**CENTER FOR DRUG EVALUATION AND
RESEARCH**

APPLICATION NUMBER:

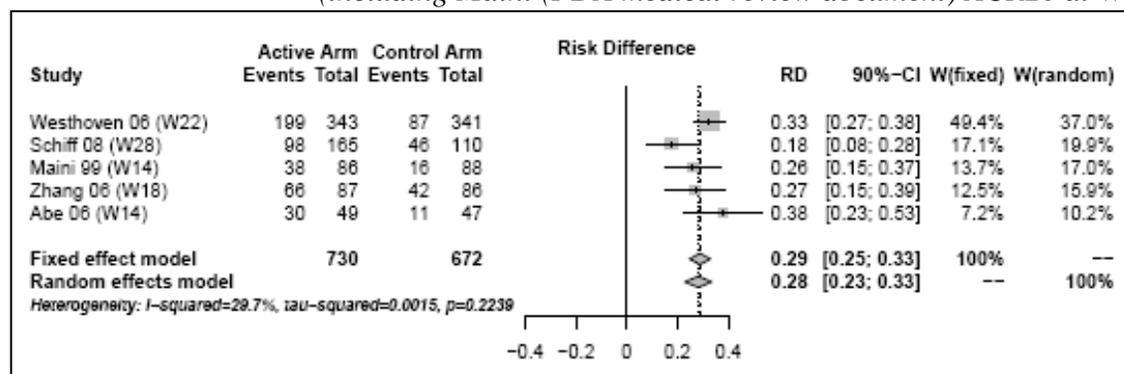
FDA response:
